Special Meeting of the Council

MINUTES

Date:	Tuesday, 31 January 2017
Time:	6:30pm
Location:	Council Chamber, Civic Centre 699 Doncaster Road, Doncaster

4.1 Planning Application PL16/026448 at 268-272 Manningham Road, Templestowe Lower for the use and development of the land for a two-storey medical centre with associated basement car park, reduction of the associated car parking requirements and alteration of access to a road in a Road Zone, Category 14

NORTH ELEVATION (MANNINGHAM ROAD)

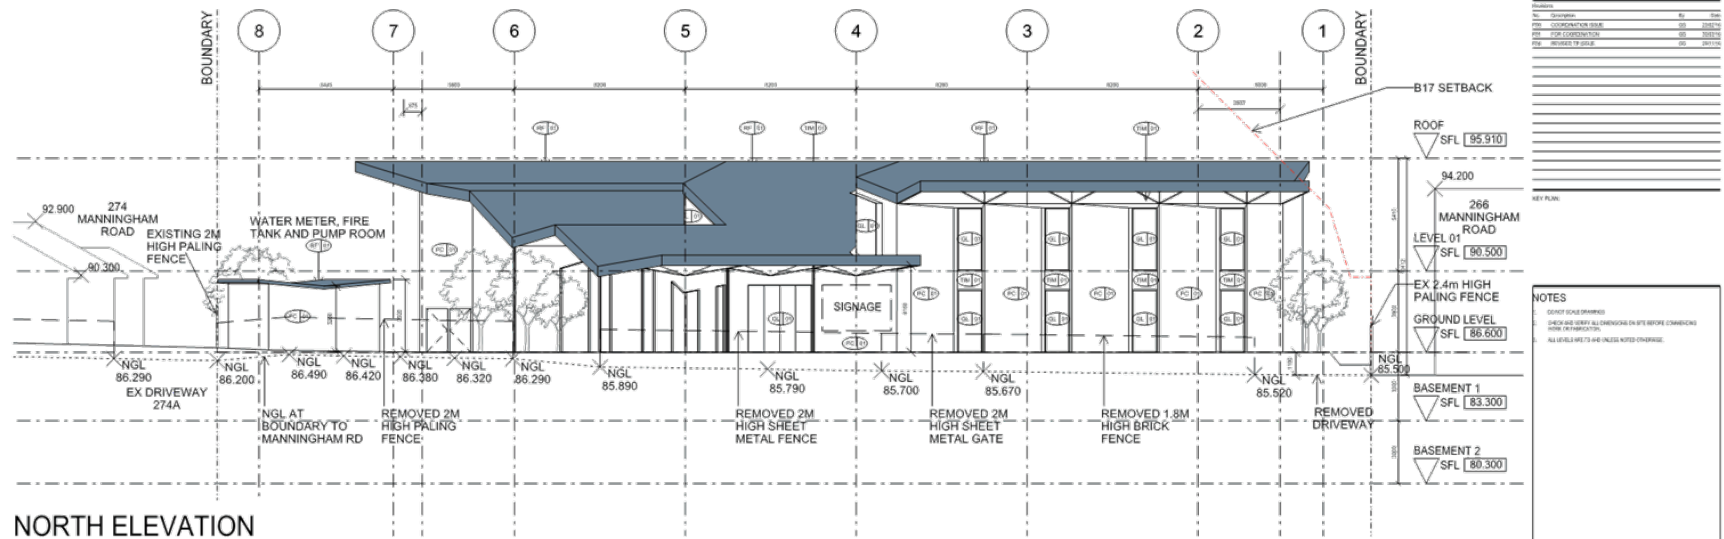
- 1.3 All batter slopes to be no steeper than 1:3 or replaced with retaining walls;
- 1.4 Deletion of all reference to advertising and the advertising signage area shown on the northern wall (north elevation plan);

Ground Floor Plan
 Manningham Rd Apartments

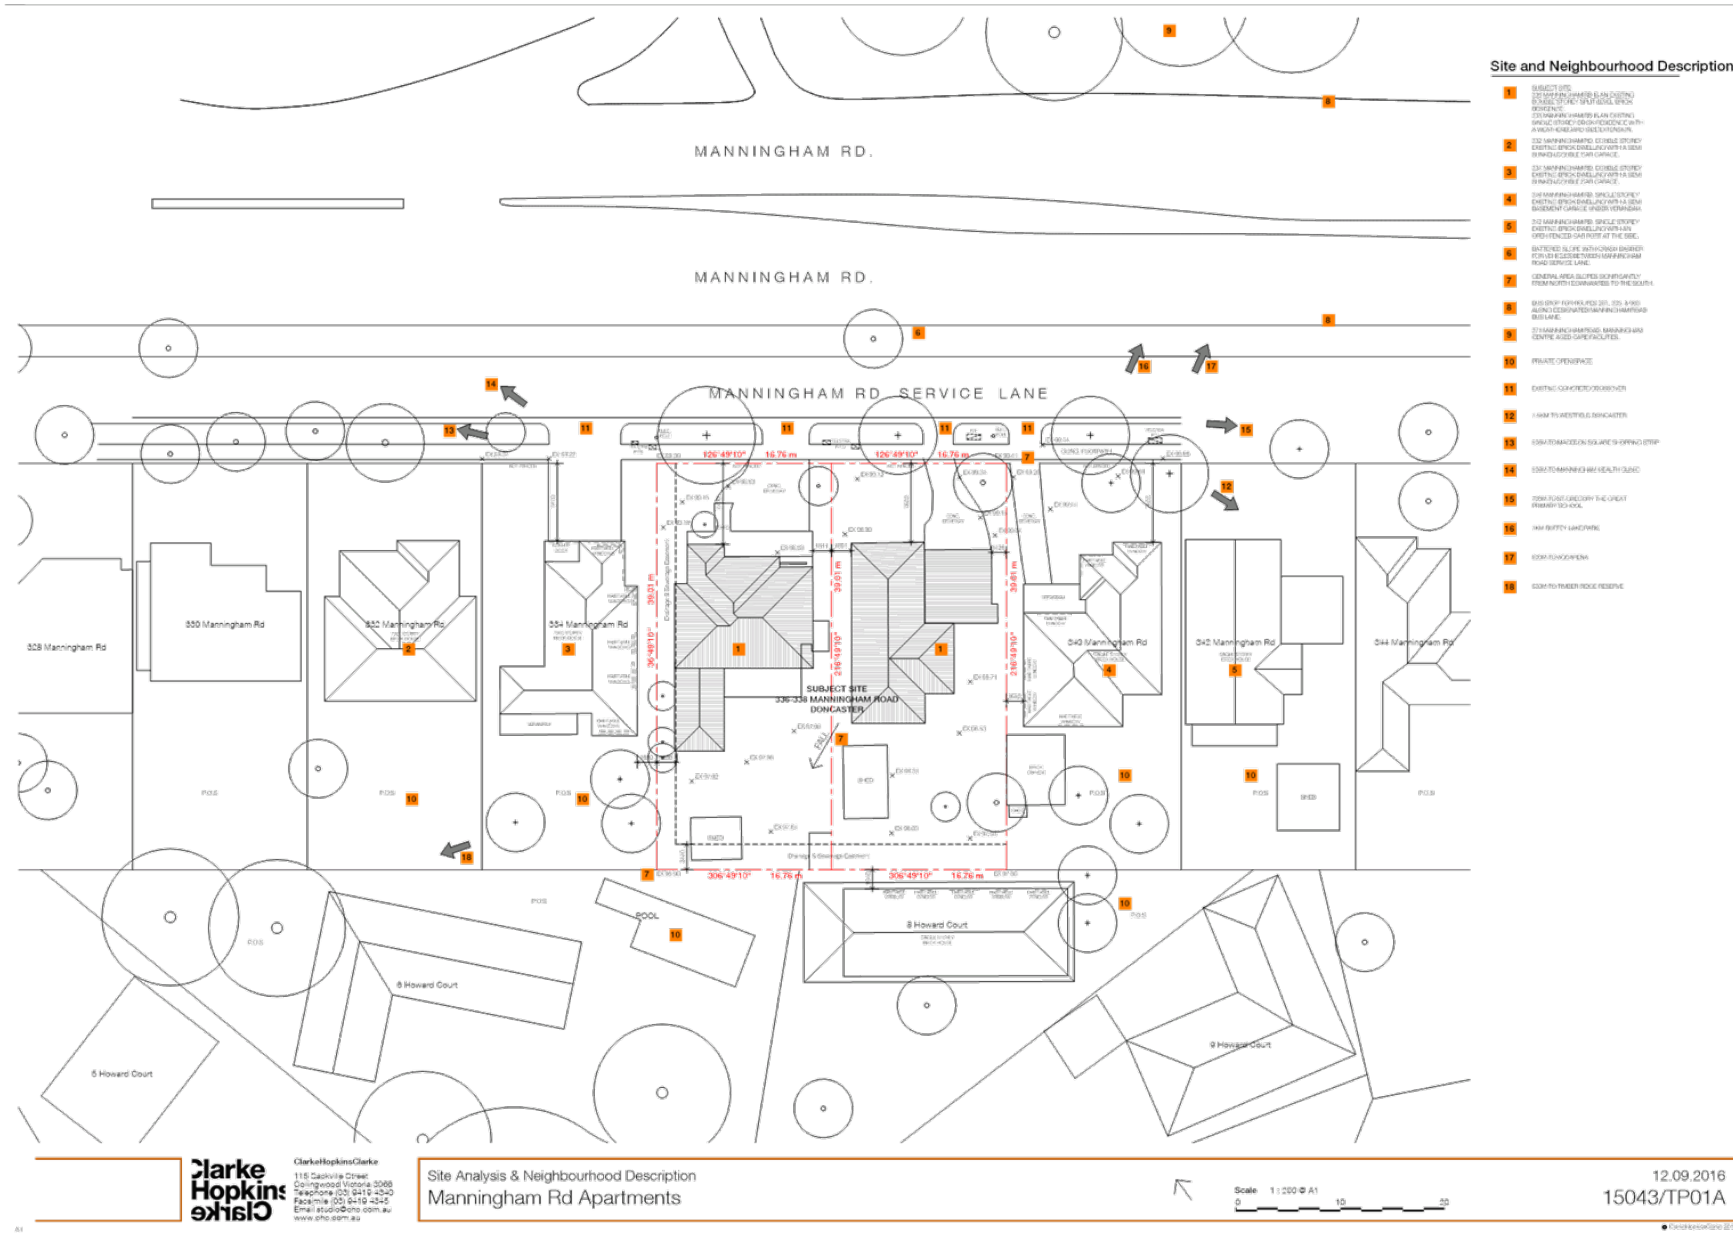
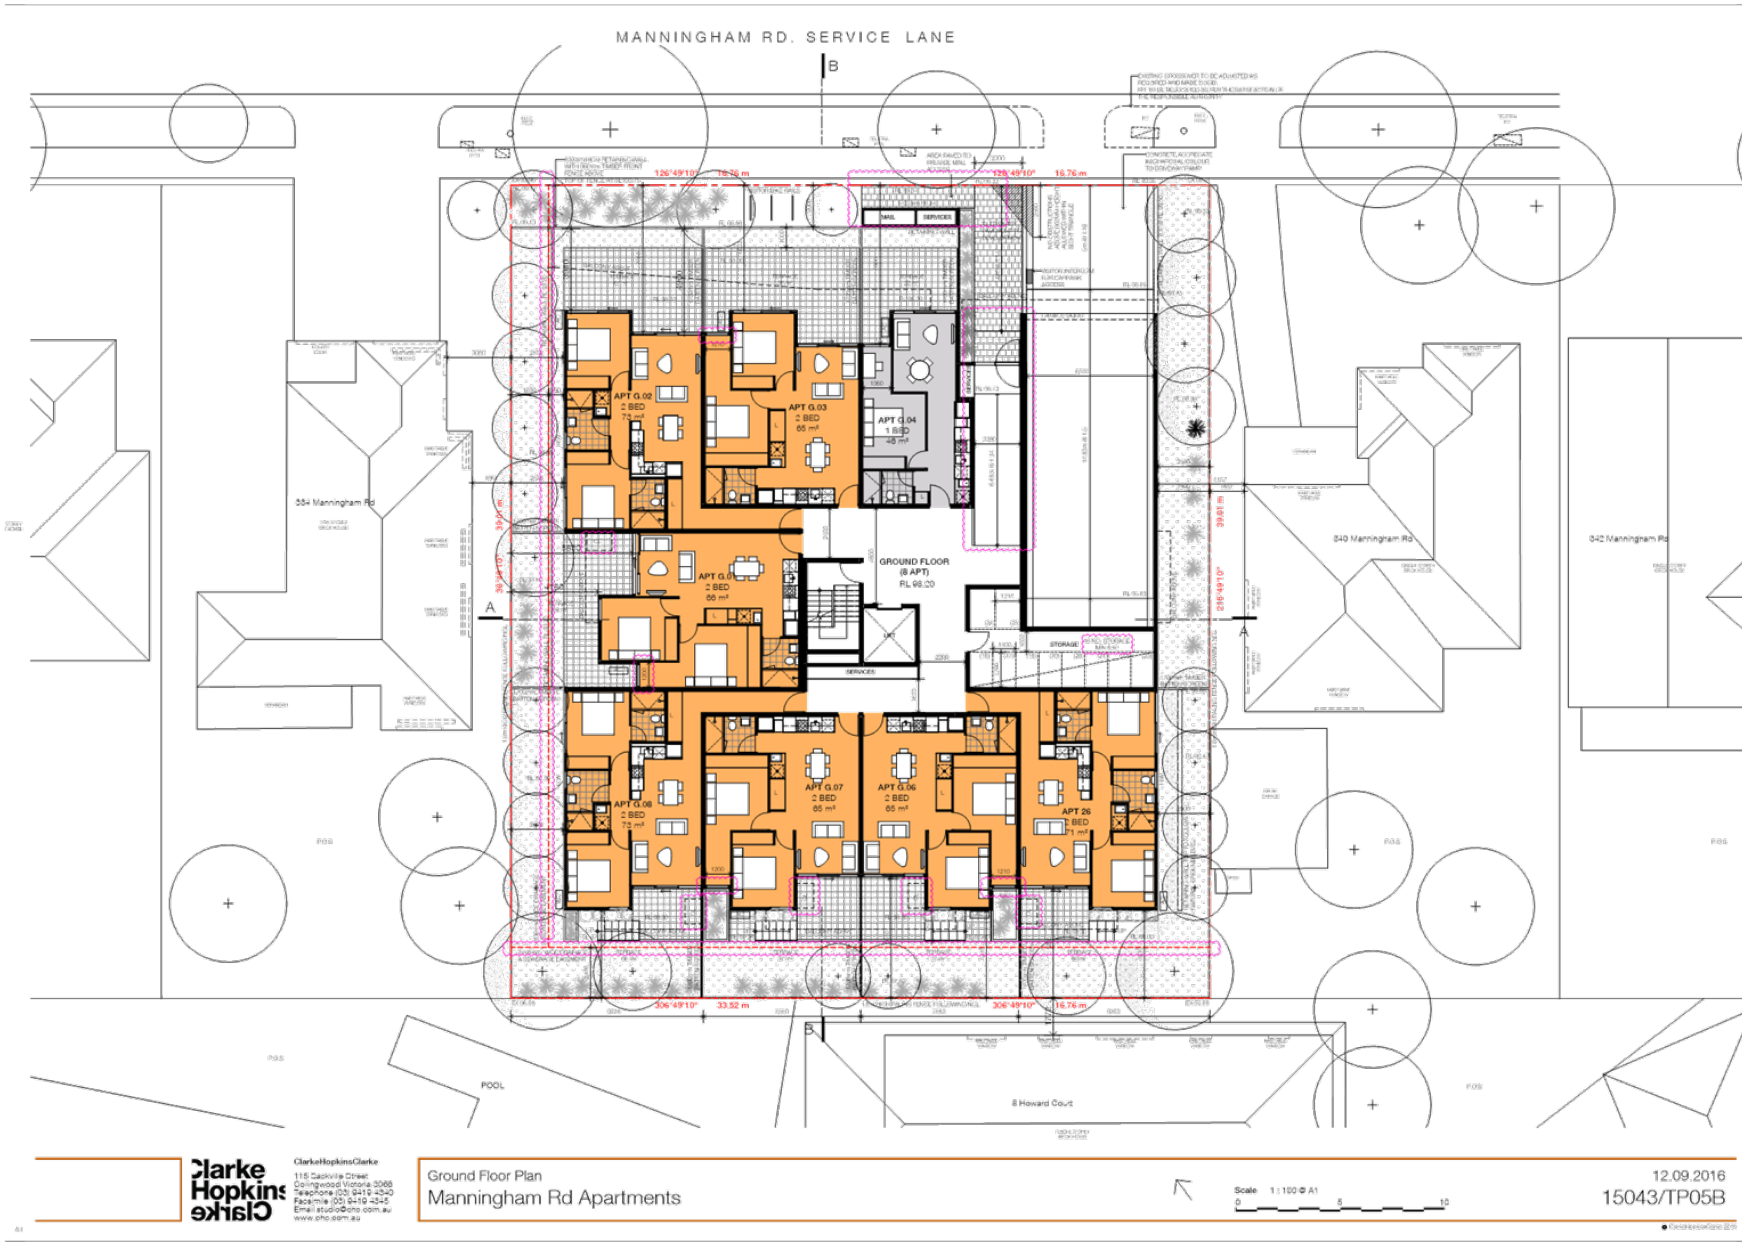
- 8.37 Apartment G.05 is indicated on the ground floor plan as Apartment 26 erroneously. A permit condition will require this Apartment be re-numbered to G.05 (**Condition 1.29**).
- 8.38 Apartment 1.01 is not numbered on the first floor plan. A permit condition will require it be numbered (**Condition 1.30**).
- 8.39 The floor level is omitted on the third floor plan. A permit condition will require the relative level 107.20 metres be shown to be consistent with the level on the section plan (**Condition 1.31**).
